PLANNING DEPARTMENT
Staff Report & Recommendation

Design Review Board

SUBJECT: DRB21-0744
2001 Lake Avenue

An application has been filed requesting modifications to an existing non-conforming garage, including relocation of the garage doors and a new driveway with direct access from Sunset Drive.

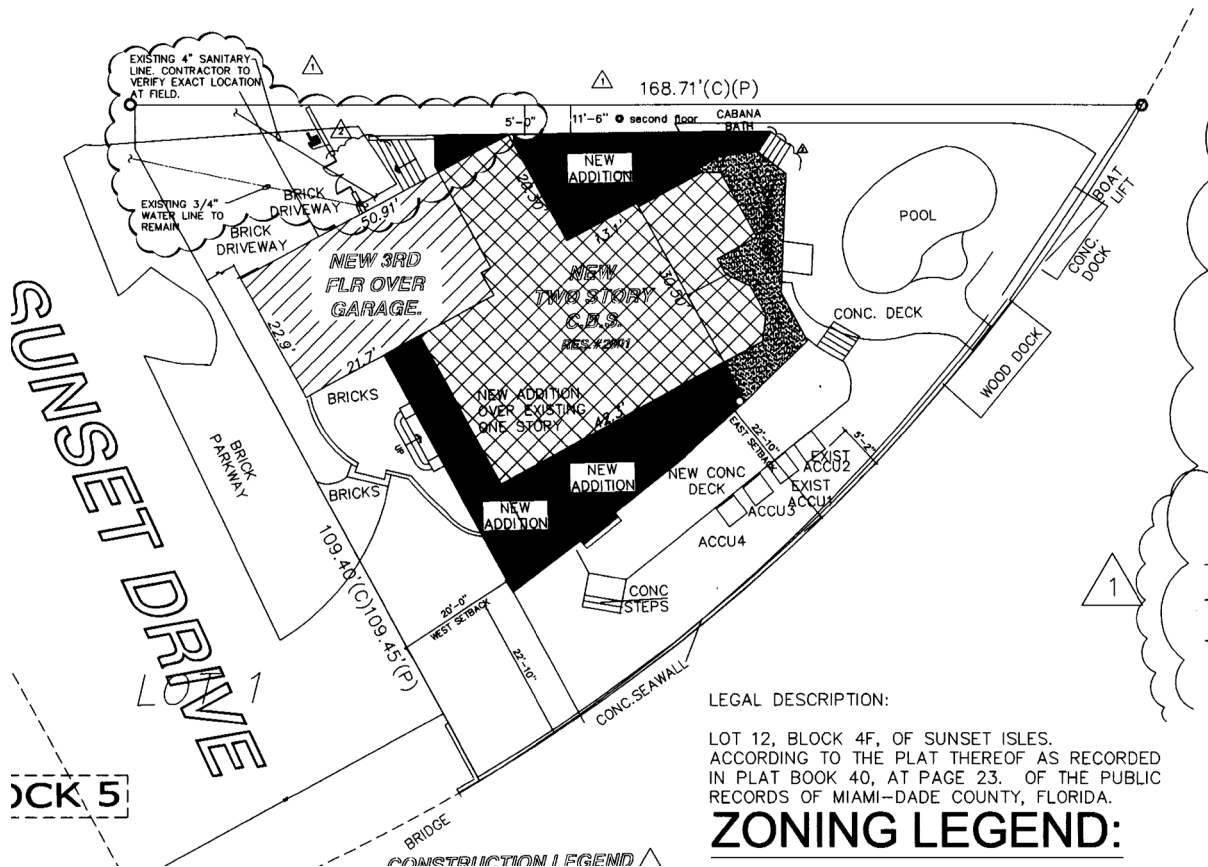
It is important to note this history, especially as it relates to the front setback of the garage structure, which is currently only 5'-3" from the front property line and where the required setback is now a minimum of 20'-0". There is an existing driveway at the northwest corner of the site that also provides a side access to the garage, with the garage doors not visible to the street.

The applicant is proposing to reorient the double garage door, from the current side access to direct perpendicular access from Sunset Drive, along with a new driveway. The proposed reorientation of the vehicular access for the garage, and the introduction of a new driveway, when combined with the existing driveway to remain, results in an excessive amount of paving in the swale and a reduction in landscaping. The existing house is already larger than what could be constructed today, with a unit size of 76% (maximum is 50%), and a lot coverage of 41% (maximum is 30%). Combined with the existing reduced setbacks, the current side access garage and one driveway to access the property, helps to mitigate the scale and mass of the current home, and its impact on the surrounding neighborhood.

Staff would also note that this property is highly visible at the entrance to Sunset Island 4 with access from one of the 4 historically designated Sunset Island Bridges. For this reason, as well as the reasons stated above, staff believes that the current driveway configuration and side garage access should remain, and the that the subject application be denied.
